June 30, 2015

Reference No. 1214280022-018-L-Rev0-11000

**RESPONSE TO MINISTRY OF ENERGY AND MINES MEMORANDUM DATED FEBRUARY 3, 2015
REGARDING THE BEAVERDELL TAILINGS FACILITIES**

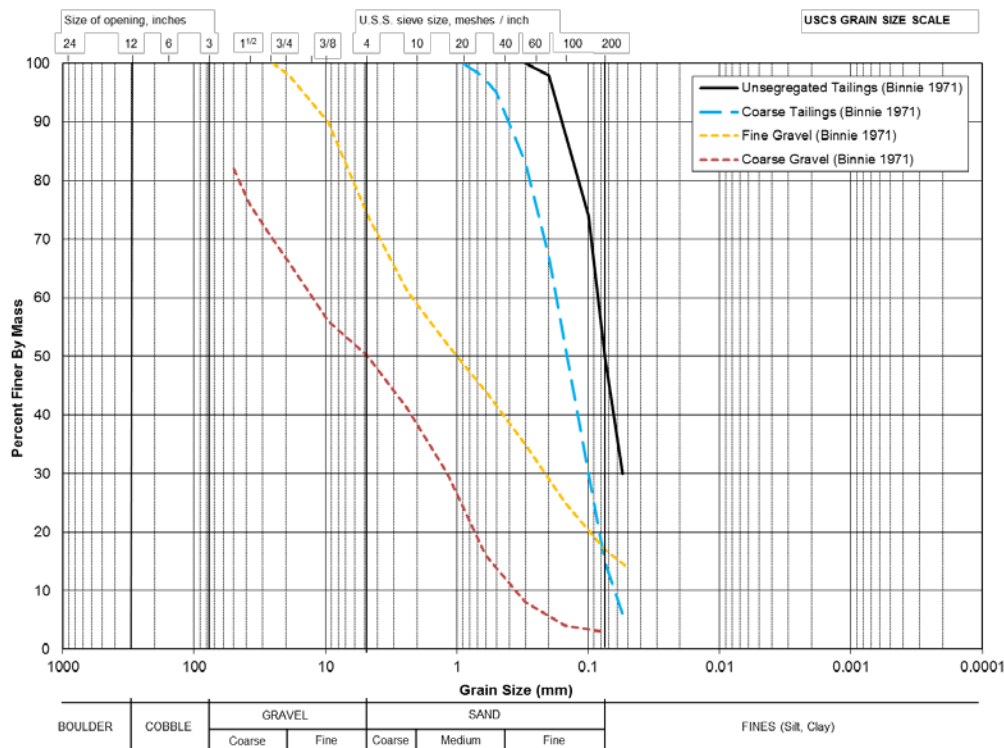
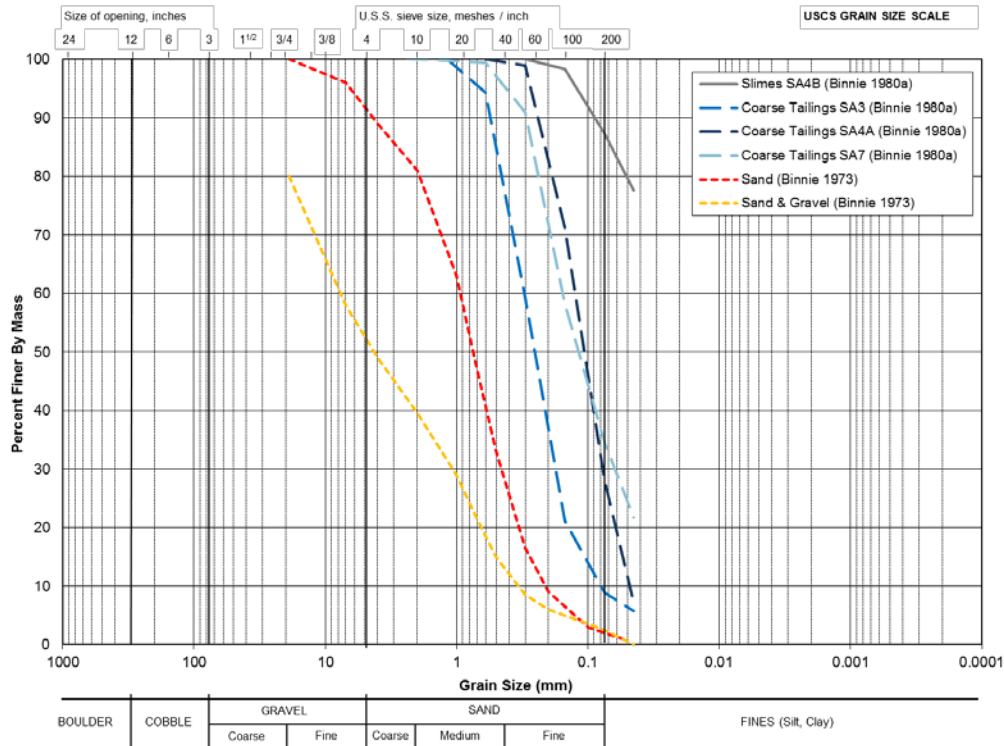
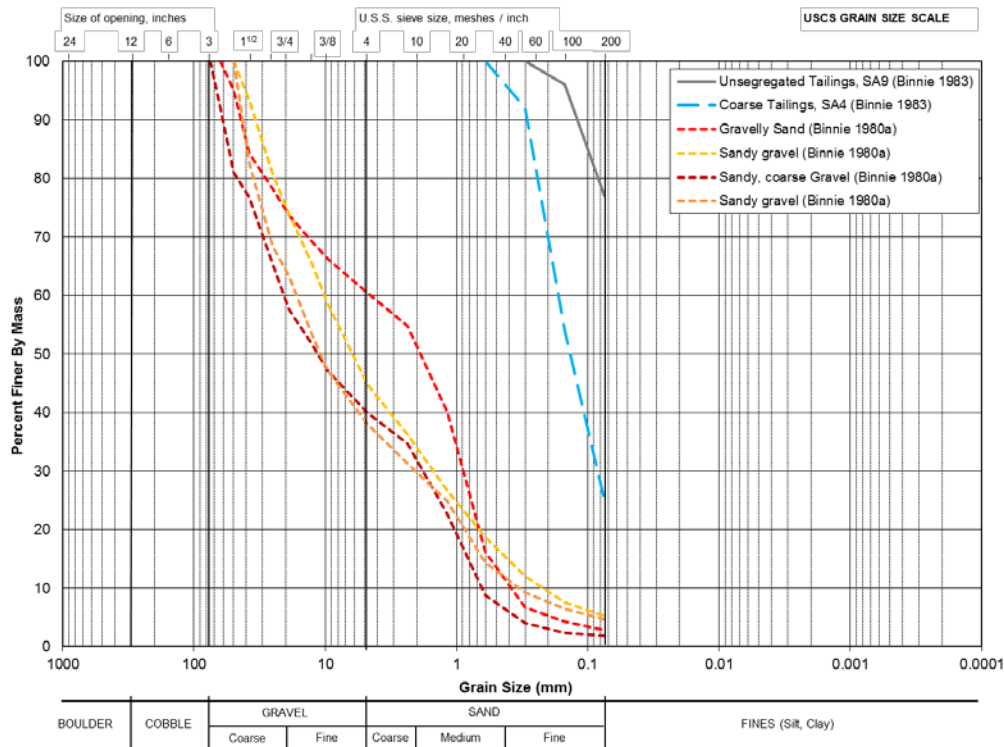
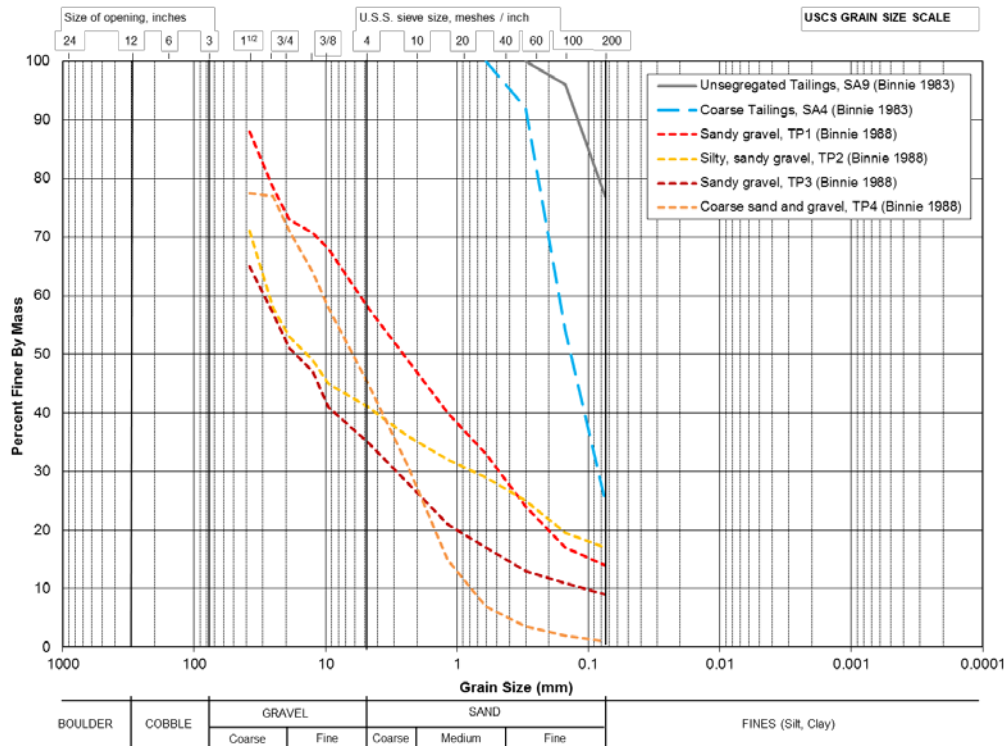
b) Whether or not the filter has been constructed in accordance with the design.

There are no known design or construction records for Ponds 1, 2, or 3. Binnie (1971) indicates that Pond 4 experienced tailings migration through the dam section during the winter of 1970/1971. In response to this event, coarse rock was placed on the downstream slope of a section of the Pond 4 dam and operations were change to spigotted deposition to deposit coarse tailings against the upstream slope and push the slimes toward the centre of the facility (Binnie 1971). Samples of the gravels used for construction of Pond 4 were taken (Binnie 1971). Binnie (1973) followed up on the tailings deposition recommendations from 1971 and tailings samples were taken from Pond 4 to compare the gradation of tailings deposited near the dam faces against the unsegregated tailings. The tailings against the upstream face were found to contain less fines than the unsegregated tailings, which confirmed a wedge of coarse tailings was being successfully developed to act as a filter. The remedial measures directed in Binnie (1971) were determined to have been successful (Binnie 1973).

Available records indicate that design reports for Ponds 5, 6, and 7 required that operations create a wedge of coarse tailings against the upstream slope of the TMF dams to act as a filter for the slimes. Samples of the tailings were taken once deposited to confirm the coarse tailings wedge (beach) was being created and spigotting methods were observed (Binnie 1980a, 1983, 1988a).

Gradations of the coarse tailings (beach) are filter compatible with the gradations of the slimes for samples taken in Ponds 4, 5, 6, and 7.

Gradations of the coarse tailings (beach) are filter compatible with the gradations of the sand and gravel dam for all samples taken except for the coarse sand and gravel from test pit (TP) 4 in Pond 7. However, Pond 7 was never filled with tailings, so this gap represents a low risk for piping failure.
